CITY OF ALBUQUERQUE

RE: Circle K – 9620 Eagle Ranch Rd. NW
Conceptual Grading & Drainage Plans
Engineer's Stamp Date: No Date
Hydrology File: C13D028

Based upon the information provided in your submittal received 12/21/2022, the Conceptual Drainage Management Plan **is not** approved for action by the Development Facilitation Team (DFT) for Site Plan for Building Permit. The following comments need to be addressed for approval of the above referenced project:

GR01

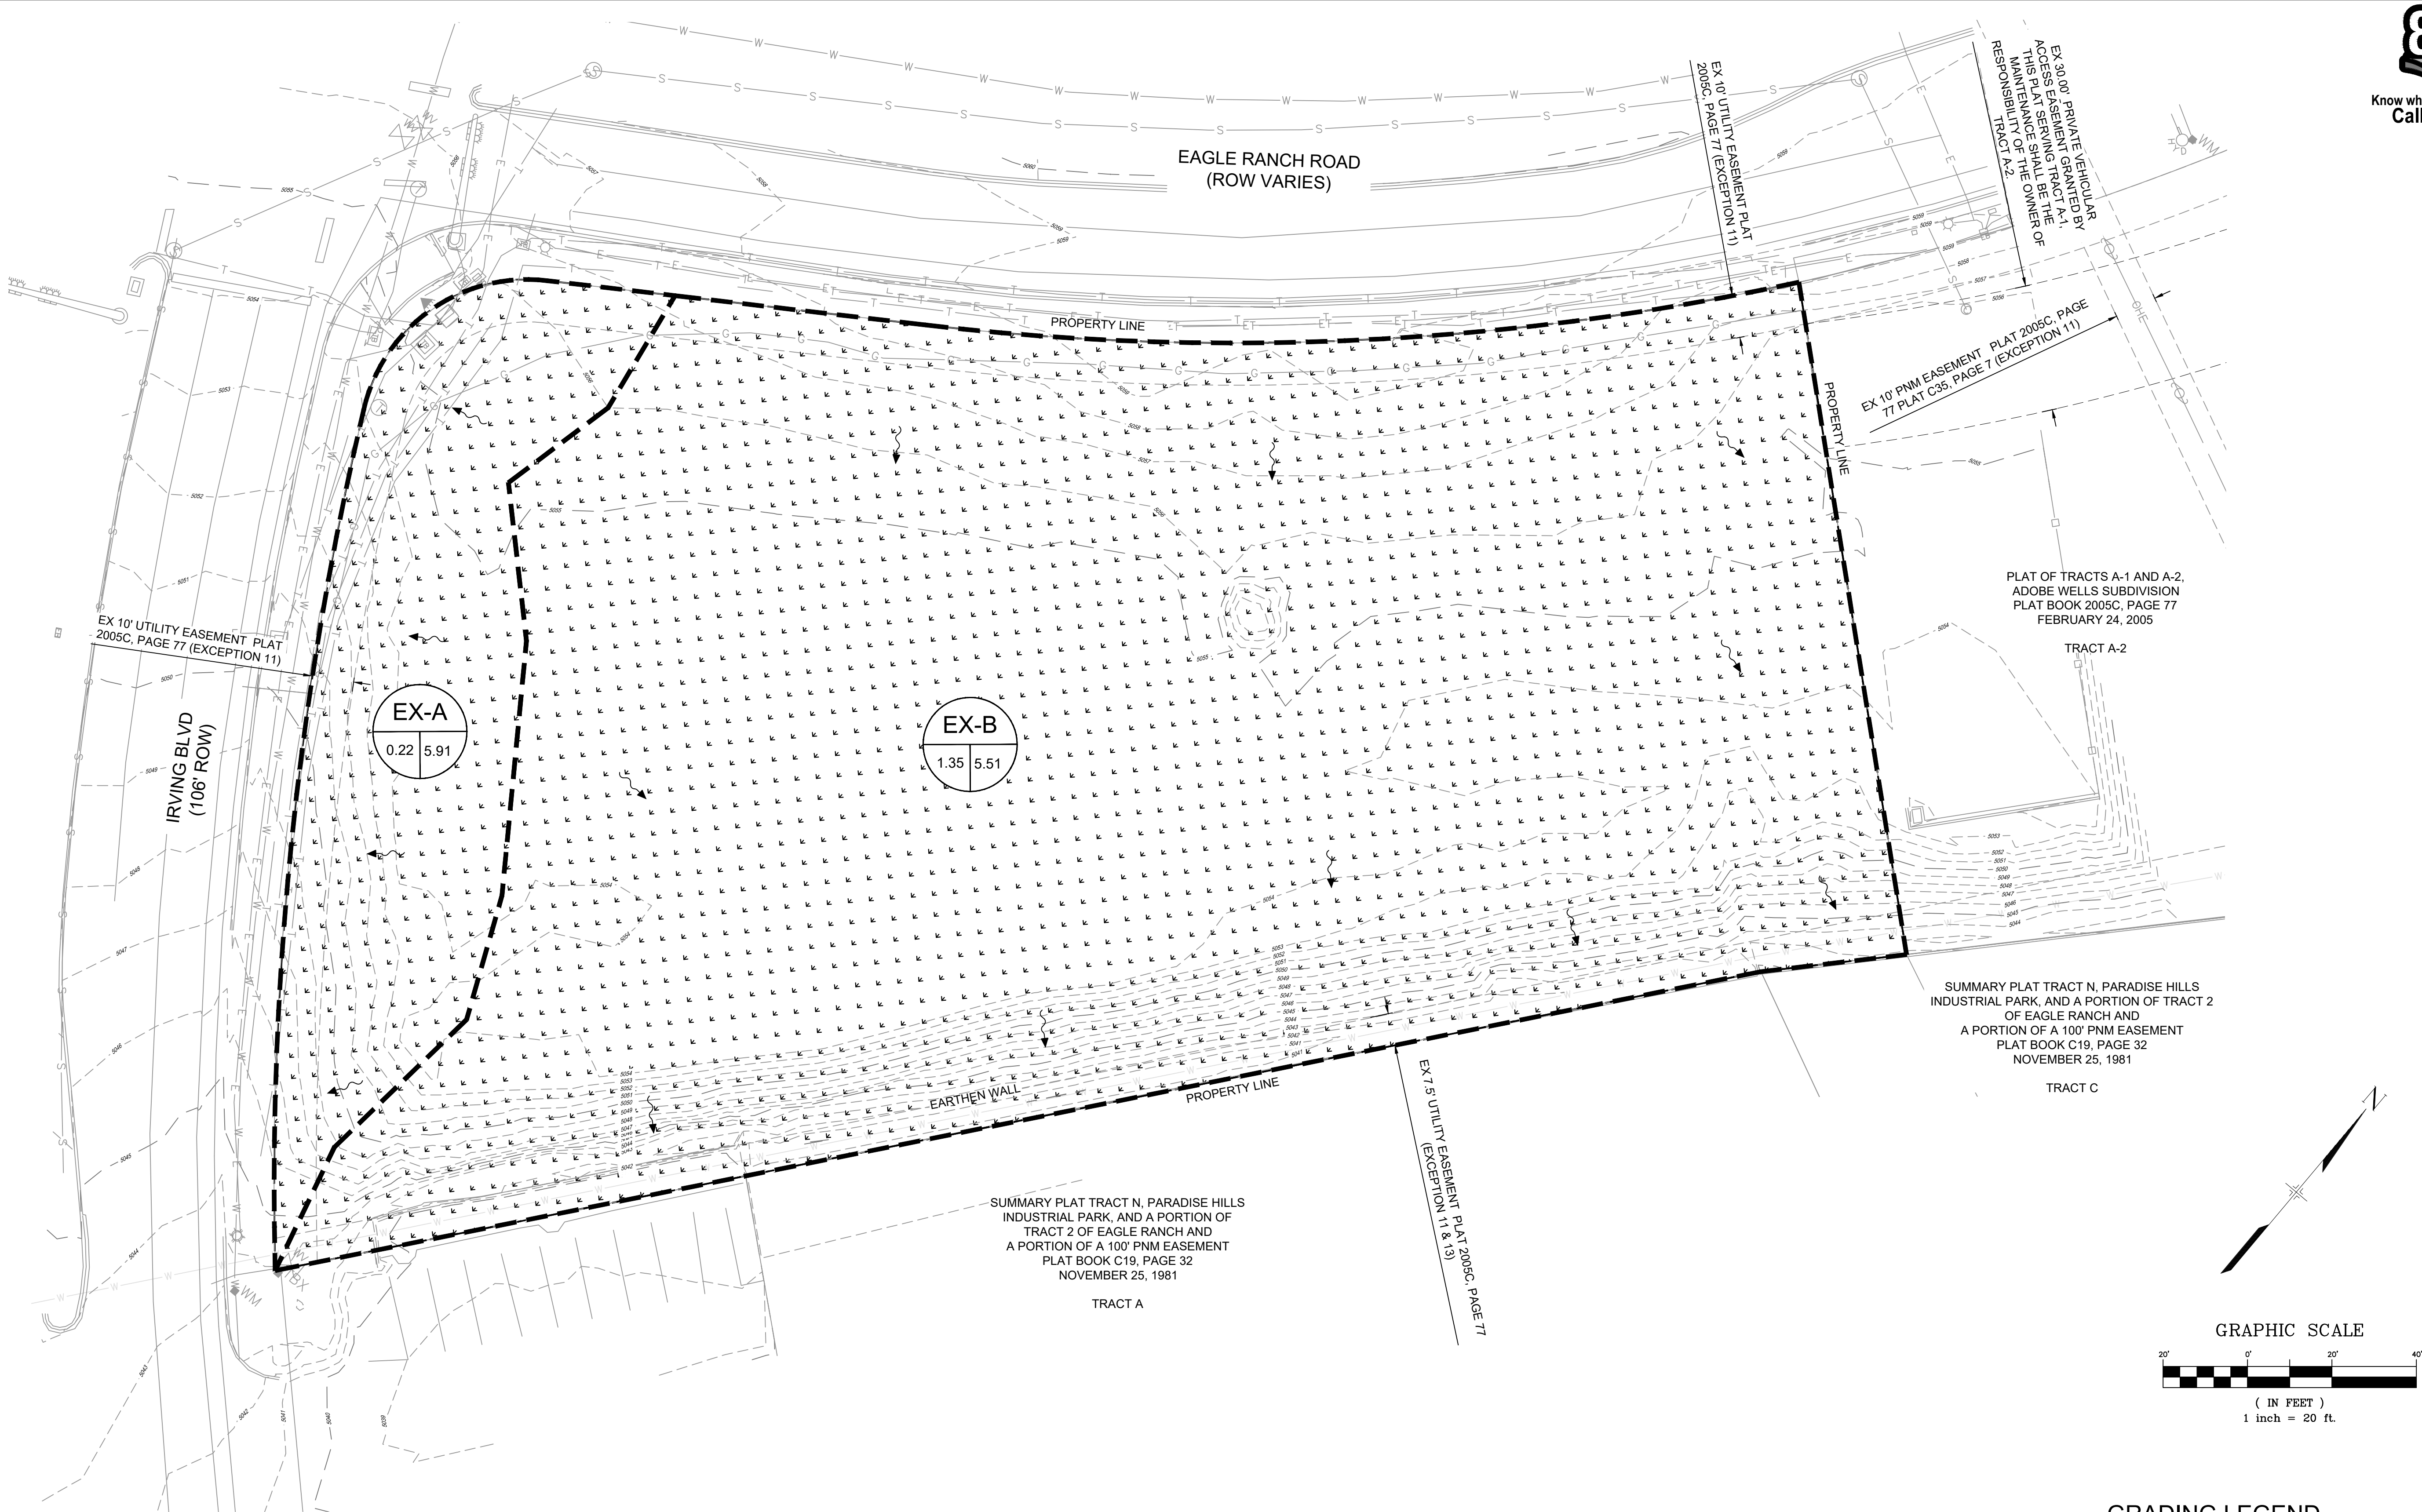
2. Please use the procedure for 40 acre and smaller basins as outlined in Development Process Manual (DPM) Article 6-2(a). Please provide both the existing conditions and proposed conditions for the 100 year-6 hour storm event.

GR02

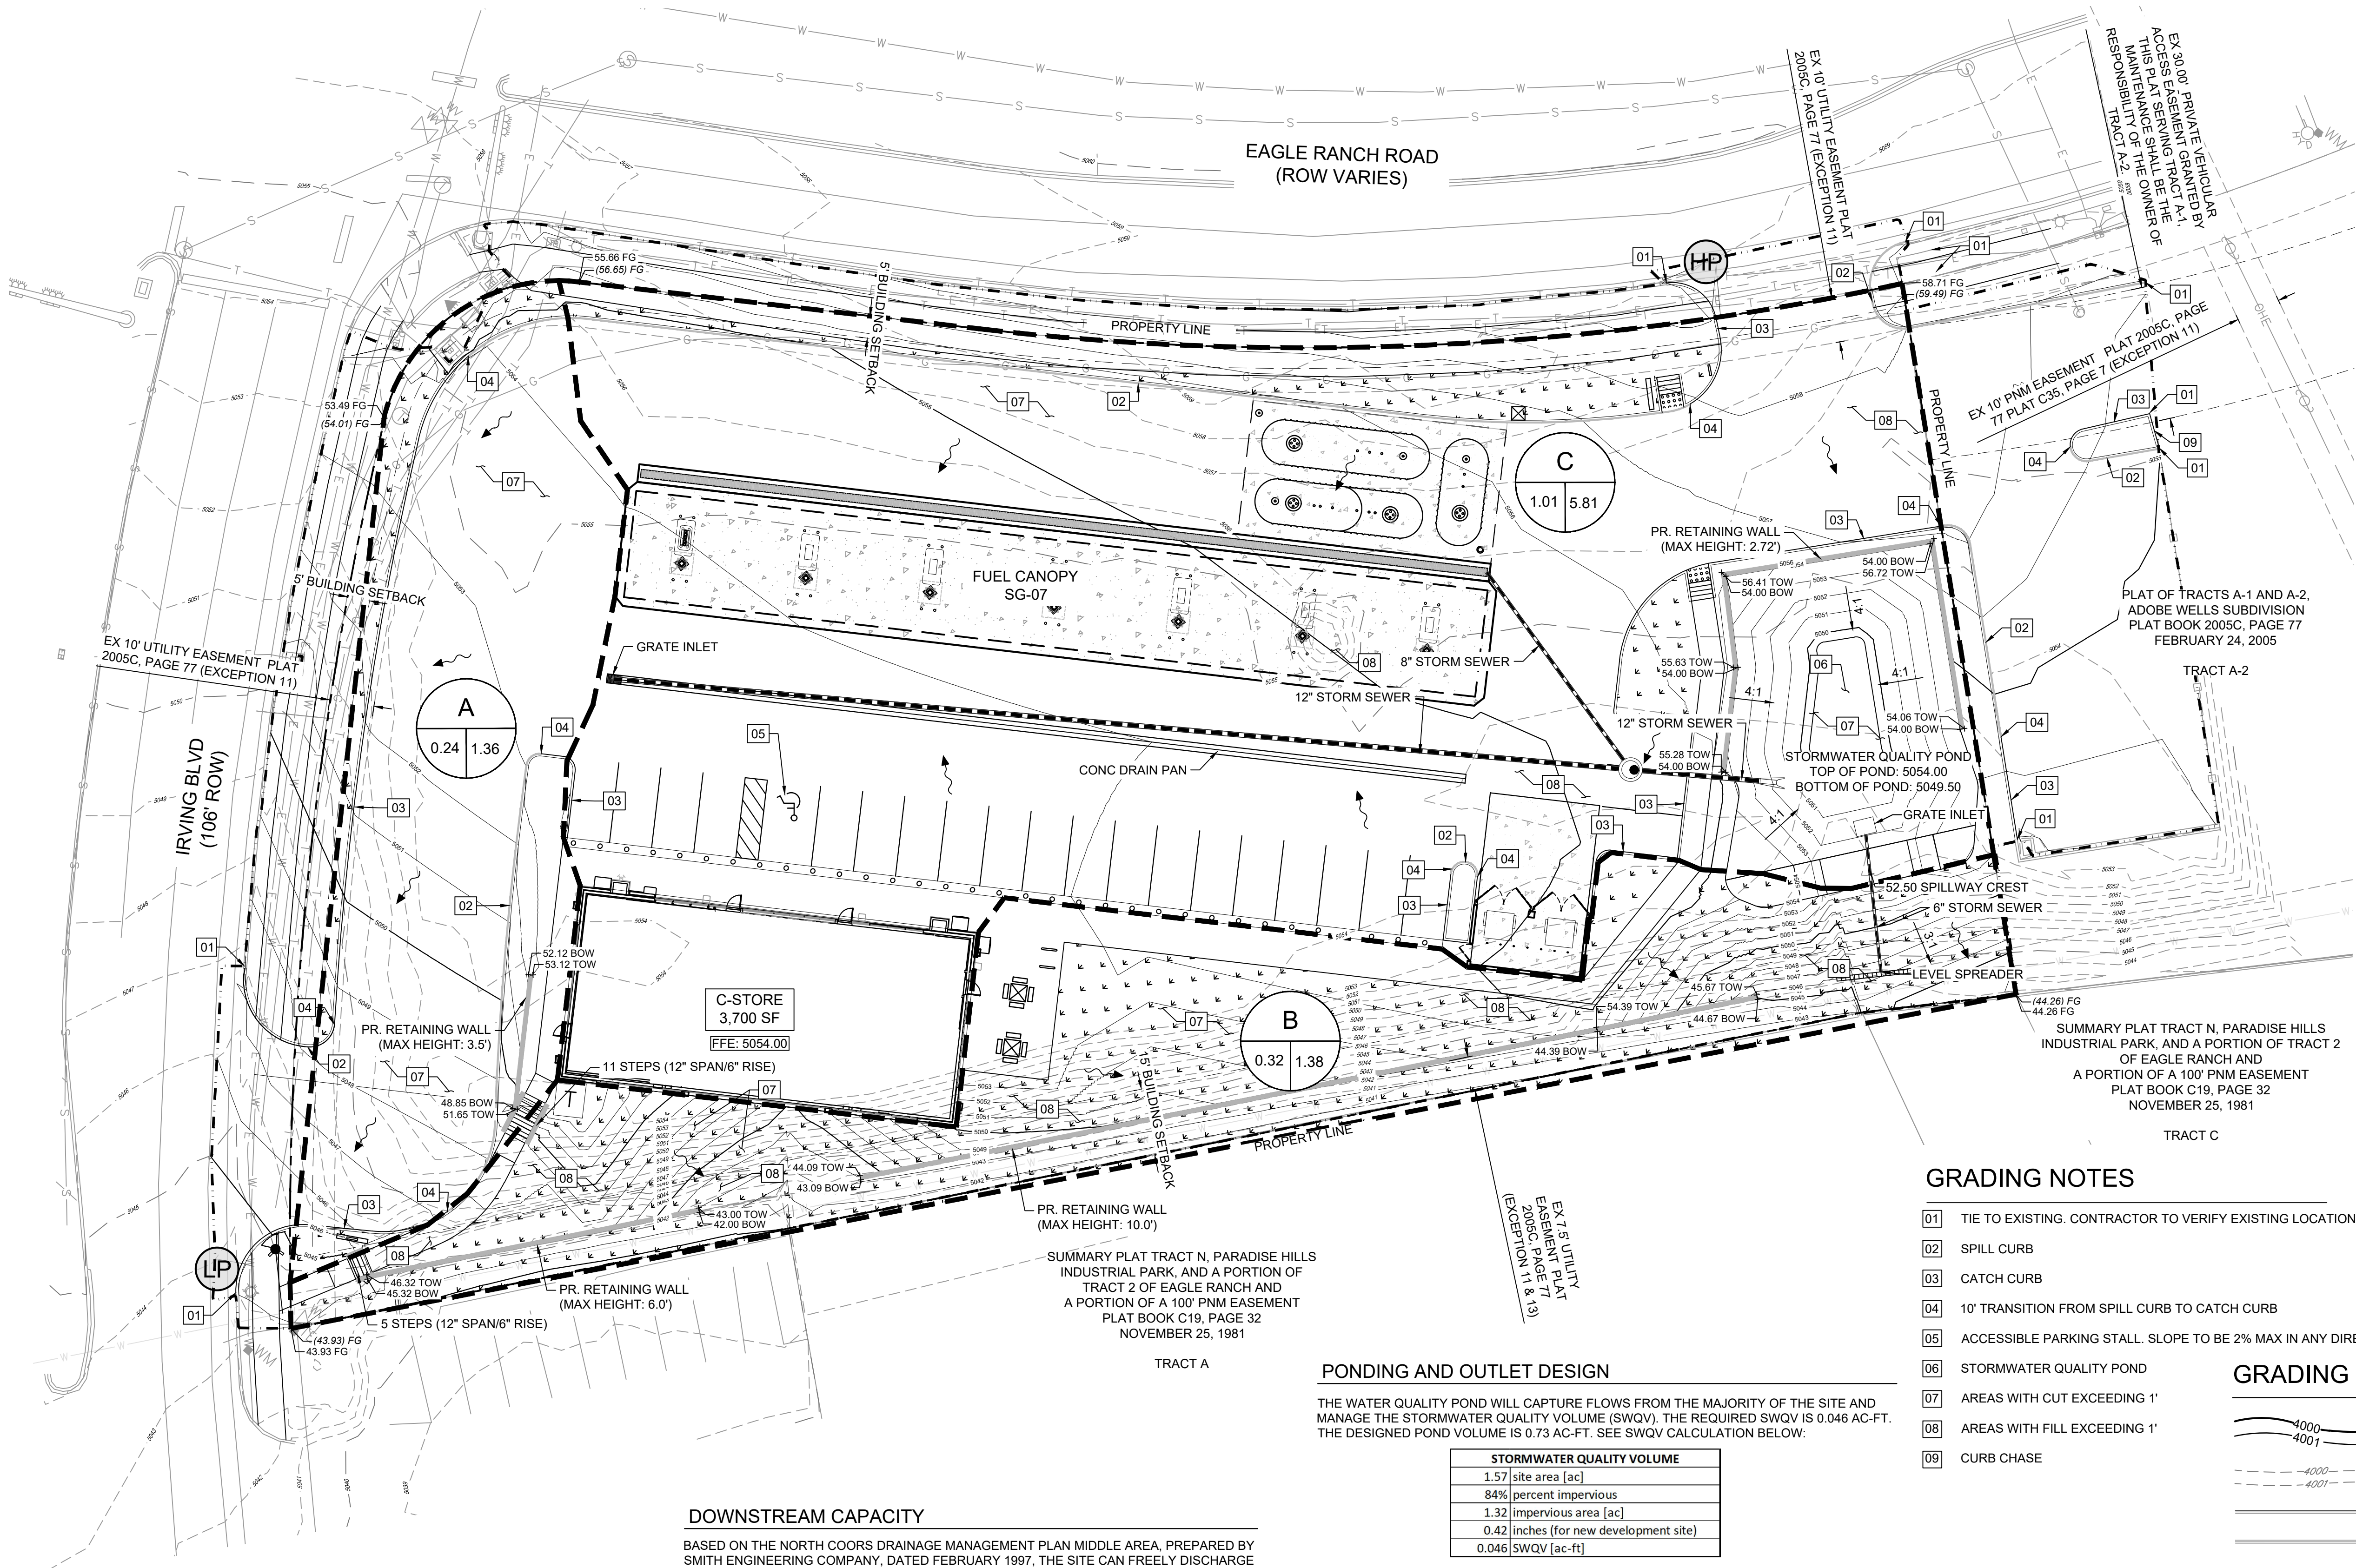
3. Please follow the DPM Article 6-12 Stormwater Quality and Low-Impact Development for the sizing calculations. To calculate the required SWQV, multiply the impervious area draining to the BMP by 0.42 inches for new development sites. For this site, the impervious area is 1.24 AC or **54,014.4 SF**. Times the SF by 0.42 then divide by 12. This gets a required SWQ volume of **1,890.50 CF**.

4. Please provide sections of the Stormwater Quality Pond. This should include the top of pond elevation, bottom of pond elevation, side slopes, Stormwater Quality water surface elevation (the required volume). Also include items such as retaining walls, pipes with inverts coming into the pond, and the outfall structure or emergency spillway.

5. All gas stations must drain to an oil/water separator (the Owner's choice) prior to discharge. This is mainly for the area around the pumps so some previous stations have placed this prior the remainder of the runoff going into the Stormwater quality pond. Since this site appears to be collected in a pipe system, instead of a manhole, this can be an oil/water separator.

- Please provide a 6-in swale along the south property line to direct the SWQ Pond's flow to Irving Blvd. At the R.O.W., please a 2-ft sidewalk culvert and reference City of Albuquerque standard detail No. 2236 – Sidewalk Culvert with Steel Plate Top at the sidewalk culvert.

- Per the IDO § 6-4(Q), the property owner of the property is responsible for building the sidewalks along both Eagle Ranch Rd and Irving Blvd. Please consult the Transportation Section to determine the width of the proposed sidewalks. Please note ADA ramps may also be required.
